SUBJECT: **R.E. Ginna Nuclear Power Plant**
Docket No. 50-244

Response to Request for Additional Information RE: Request for Relief from Requirements for Examination of the Reactor Vessel Head Penetration Nozzles

Response to Request for Additional Information

Figure 5
Downhill Side Axial and Hoop Stress Distribution Below J-groove Weld Toe for Penetration
Nozzles with Incidence Angle of 43.5°

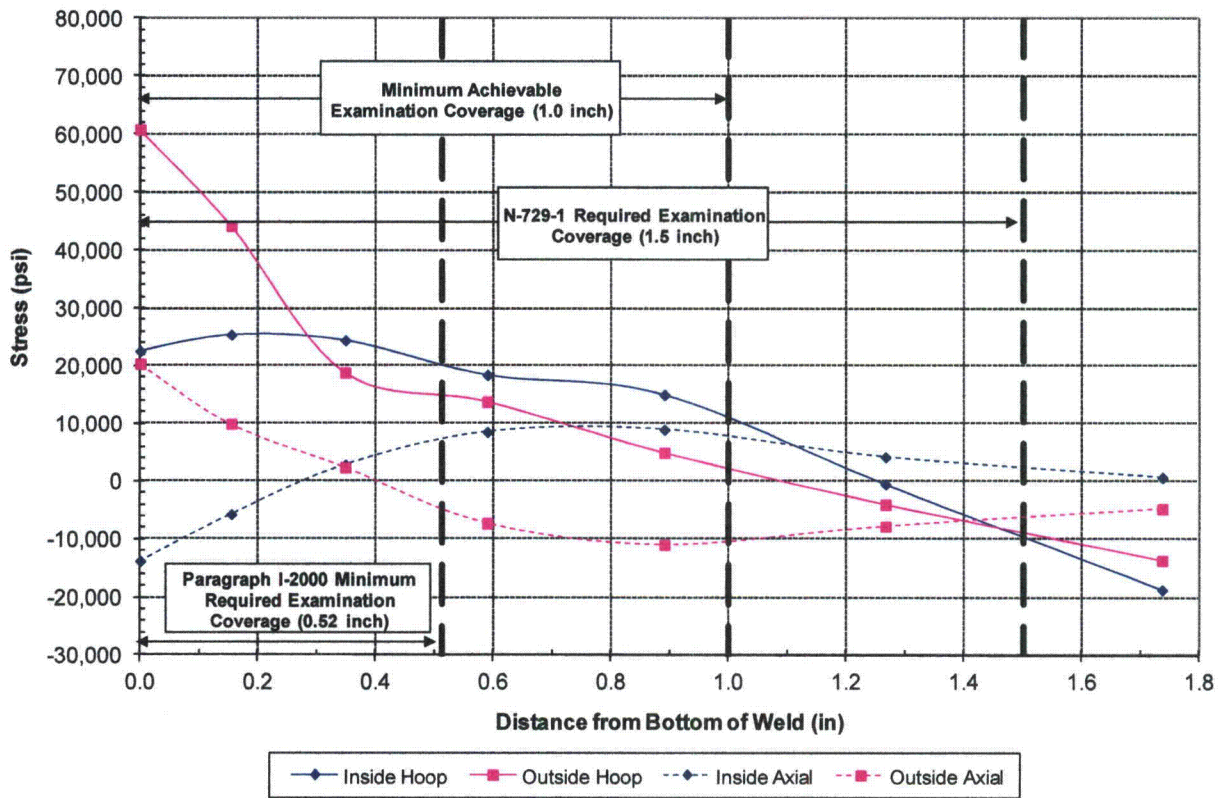
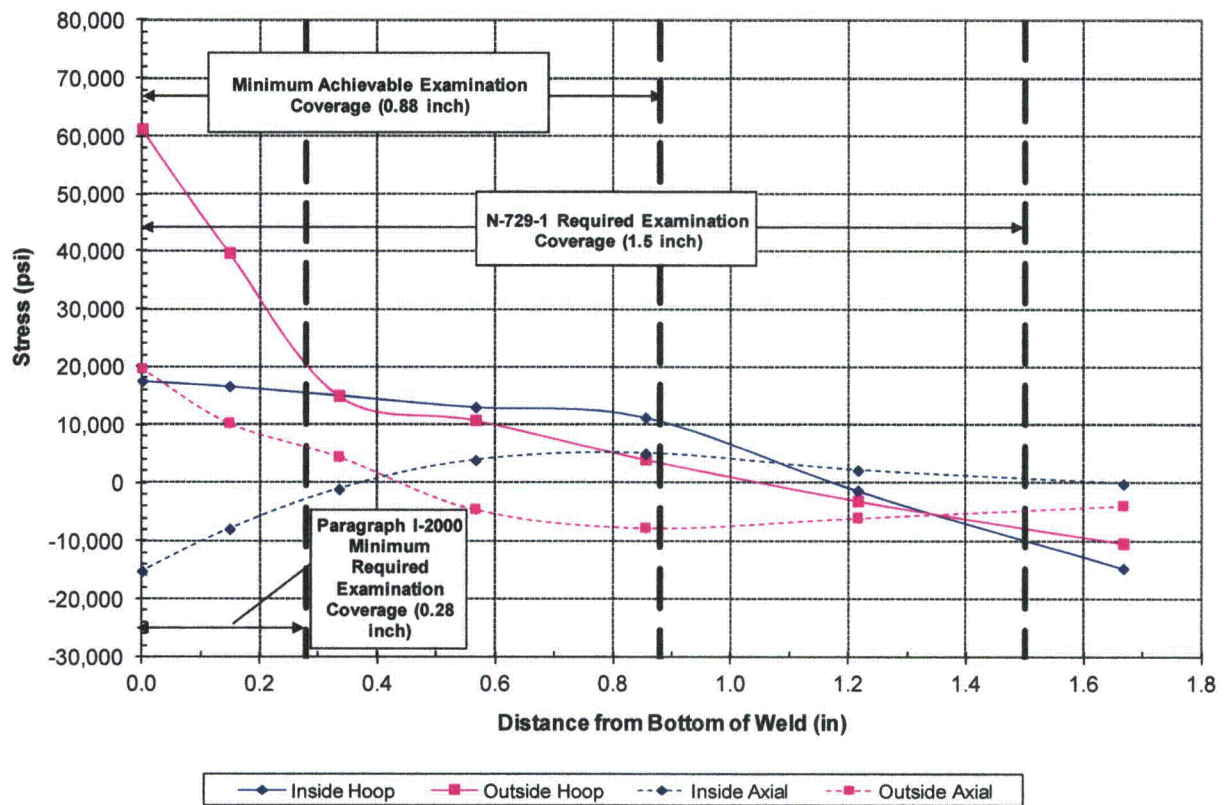
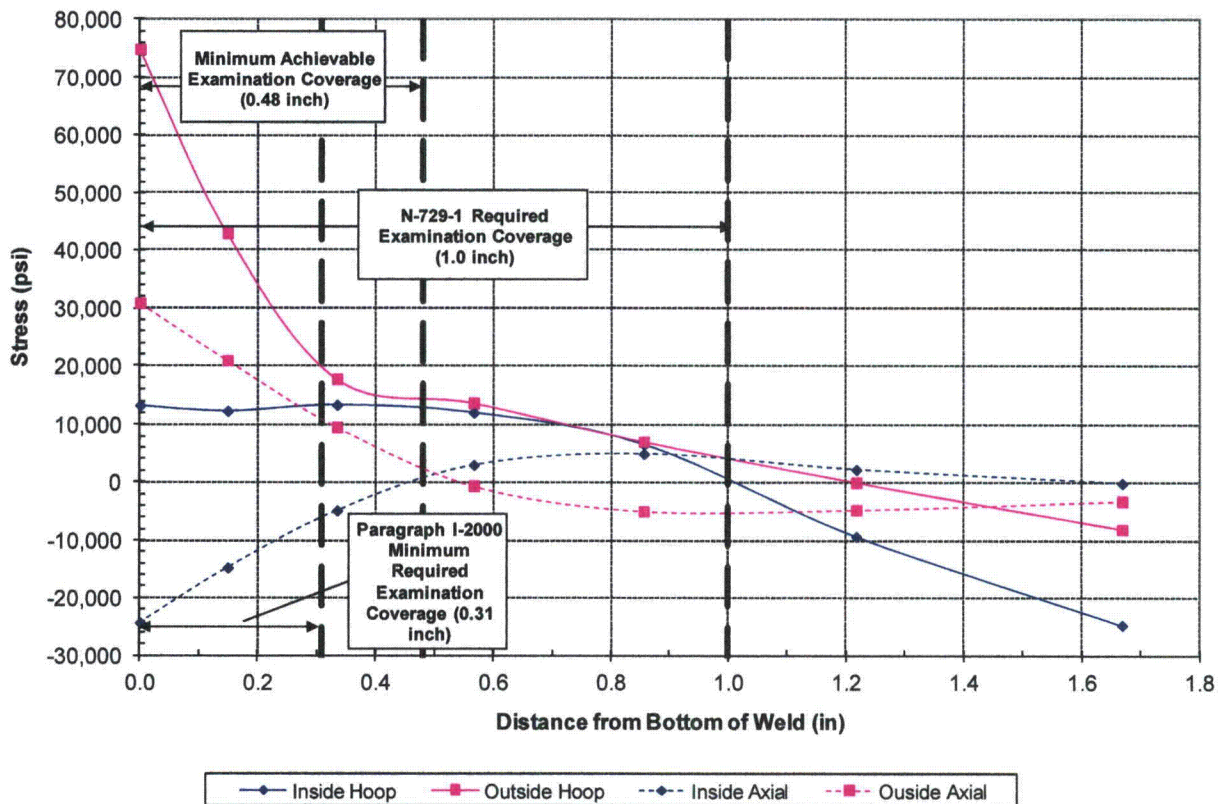
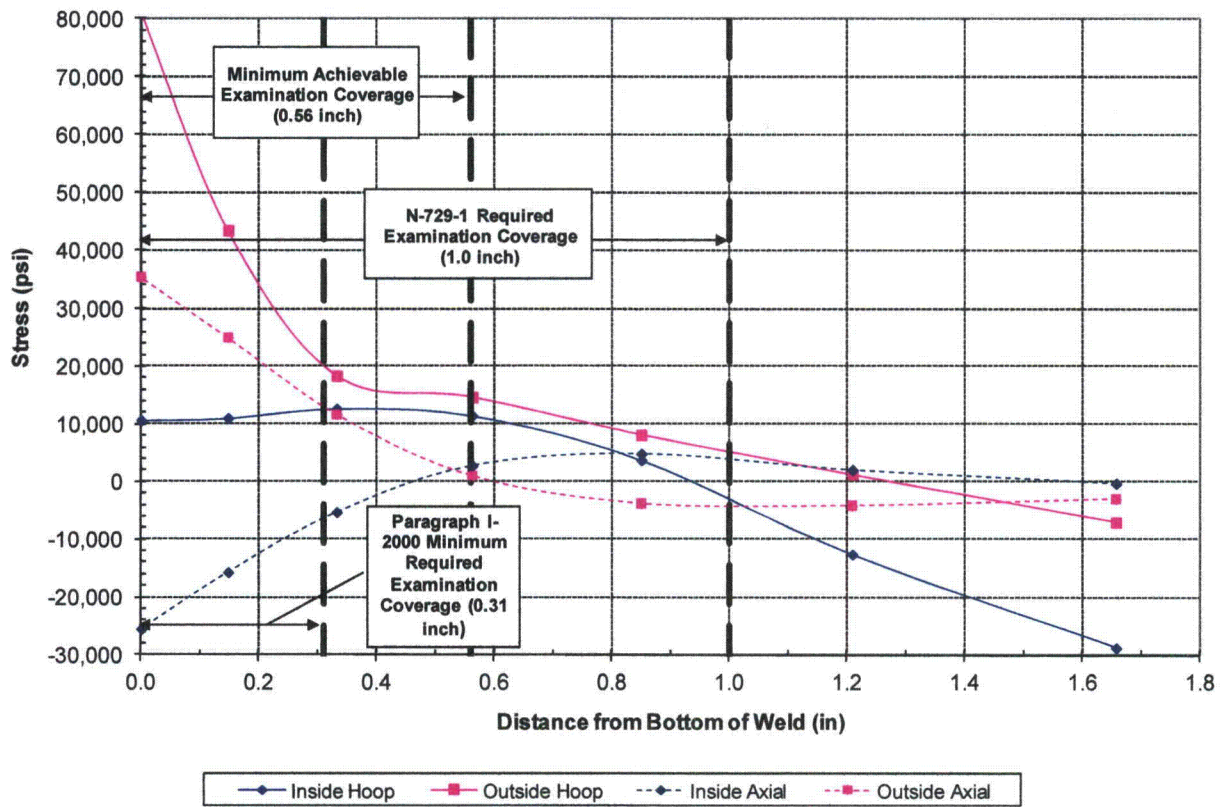
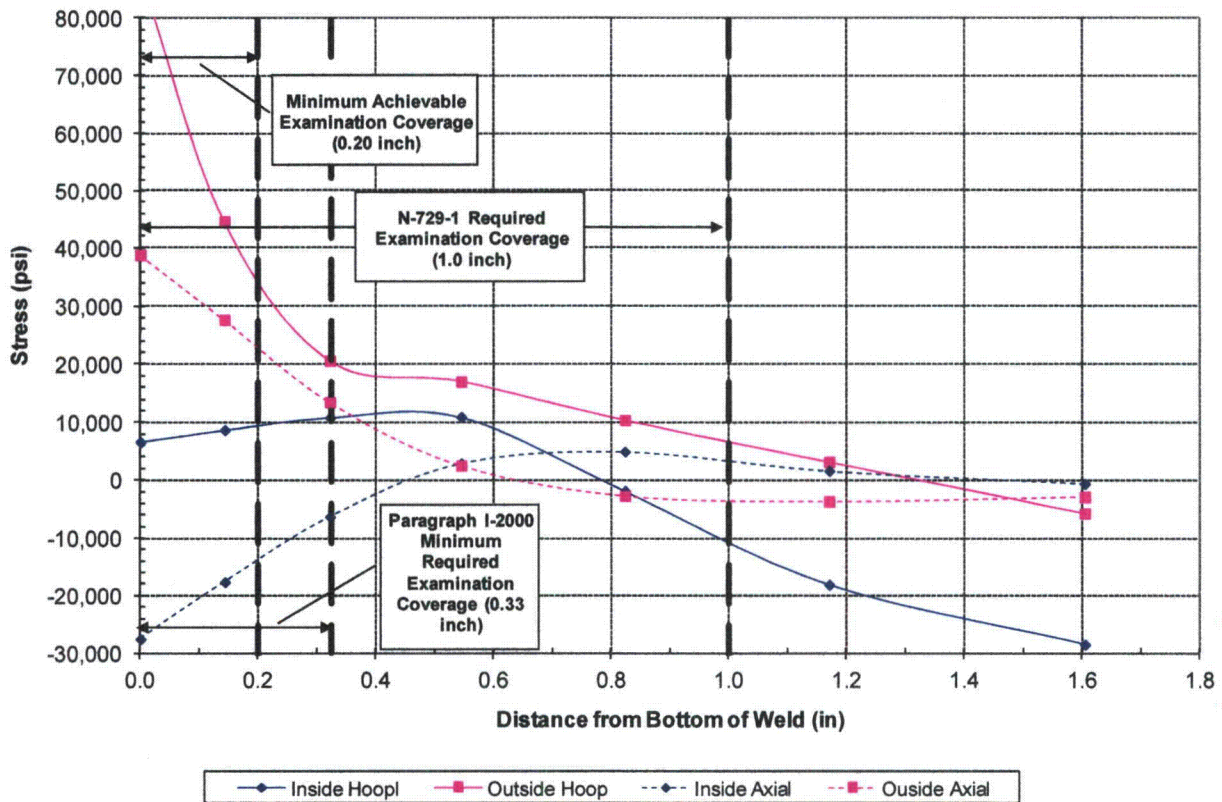
The May 24, 2012, submittal did not provide information on axial stresses for the control rod drive mechanism (CRDM) penetration nozzles on the basis that the hoop stresses are limiting. As indicated in Pacific Northwest National Laboratory (PNNL) Report 17763, "Final Report – Inspection Limit Confirmation for Upper Head Penetration Nozzle Cracking," dated August of 2008, this basis is not always true. Case 12 of Figure 9, Case 61 of Figure 11, and Cases 87, 88, 89 of Figure 13 of the PNNL report all indicated that the axial stresses are more limiting than the hoop stresses. When you study the above quoted figures in the PNNL report, please note that, for axial stresses, the longer distance from the triple point to where the stress drops to 20 ksi means that a longer portion of the penetration nozzle is at stresses greater than 20 ksi.

Please provide additional plant-specific information on axial stresses to substantiate your claim that the hoop stresses are limiting.

The attached figures 1 - 5 include Ginna plant specific axial stress plots to substantiate the Ginna position that hoop stress is limiting in the area of interest.

The licensee used a deterministic fracture mechanics analysis to justify the alternative examination coverage for penetration nozzle number 35. However, the proposed coverage of 0.2 inch is not sufficient to tolerate the uncertainties in the calculated residual stresses and the determination of the assumed crack length. The staff also has a concern with the proposed crack growth rate for Alloy 690 CRDM material (discussed in RAI-3). Hence, the NRC staff requests the licensee provide the basis for not performing a surface examination of the lower portion of each penetration nozzle necessary to meet the inspection requirements of 10 CFR 50.55a(g)(6)(ii)(D) and consider changing the regulatory basis of the relief request from 10 CFR 50.55a(a)(3)(i) to 10 CFR 50.55a(a)(3)(ii). Up to date, all similar relief requests were granted under 10 CFR 50.55a(a)(3)(ii), because the NRC staff finds insufficient basis to grant relief under 10 CFR 50.55a(a)(3)(i), considering that surface examinations could be performed on each penetration nozzle to meet the current inspection requirements.

Note: There are only three penetration nozzles (penetration numbers 34, 35 and 37) with incidence angle of 43.5°. The achievable examination coverage for penetration nozzle numbers 34, 35 and 37 from Table 1 are 0.52", 0.20" and 0.40" respectively. Only the achievable examination coverage for penetration nozzle number 35 is below the Paragraph I-2000 required minimum examination coverage.

Calculation of Initially Cold Worked Area Percentage Removed by Electropolishing

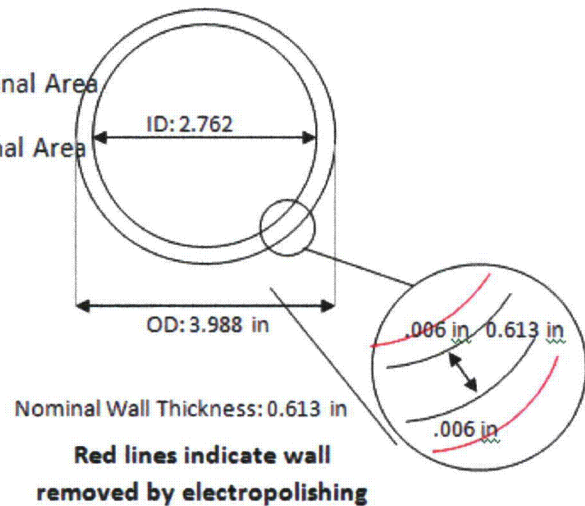
The licensee used a crack growth rate with an improvement factor of 100 over Alloy 600 for Alloy 690 materials in its fracture mechanics analyses. The May 24, 2012, submittal states that NUREG/CR-7103, Volume 2, "Pacific Northwest National Laboratory Investigation of Stress Corrosion Cracking [SCC] in Nickel-Base Alloys," indicated similar crack growth results except for high levels of cold work. However, the NUREG states, "Representative [Alloy] 690 CRDM plant materials were studied to investigate the SCC crack-growth response in the as-received TT [thermally treated] and several modified conditions." To ensure that the plant-specific Alloy 690 material for the CRDMs did not receive significant cold work which is "representative" according to the NUREG, please provide your estimate of the cold work for the Ginna CRDM penetrations based on the fabrication and installation record of the Ginna CRDM penetrations to support that the Ginna CRDM penetrations did not receive significant cold work.

Percent of Initial Area Cold Worked (subsequently removed by electropolishing)

$$\% \text{ Initial Cold Worked Area} = \frac{A_i - A_e}{A_i} = \frac{6.63 - 6.50}{6.63} = 1.96\%$$
